Clinton Power Station

Subject: Request for Amendment to Appendix A, Technical Specifications for the
Oscillation Power Range Monitor Instrumentation

DESCRIPTION AND SAFETY ANALYSIS FOR THE PROPOSED CHANGES

Figure 3.4.1-1 (page 1 of 1)
Thermal Power/Core Flow Stability Regions

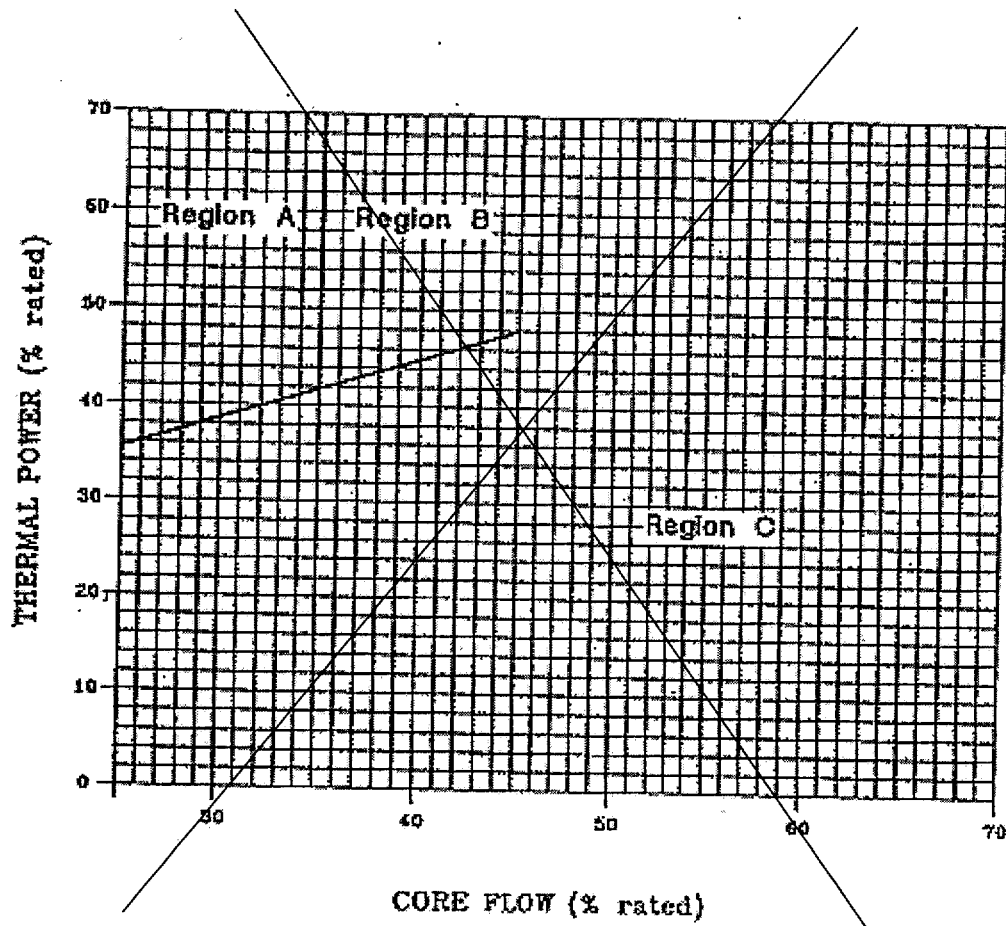
2. Due to the automatic functions provided by the OPRM instrumentation, the manual operator actions specified in TS Section 3.4.1 (and its associated Conditions, Actions, and Surveillance Requirements), which were required to be taken upon entry into a specified thermal power/core flow region of the core map, are removed. The removal of these references include elimination of LCO items 3.4.1.A.2, B.2 and B.3, removal of Actions B, C, D; G.1 and G.2, as well as deletion of SR 3.4.1.2 and Figure 3.4.1-1.
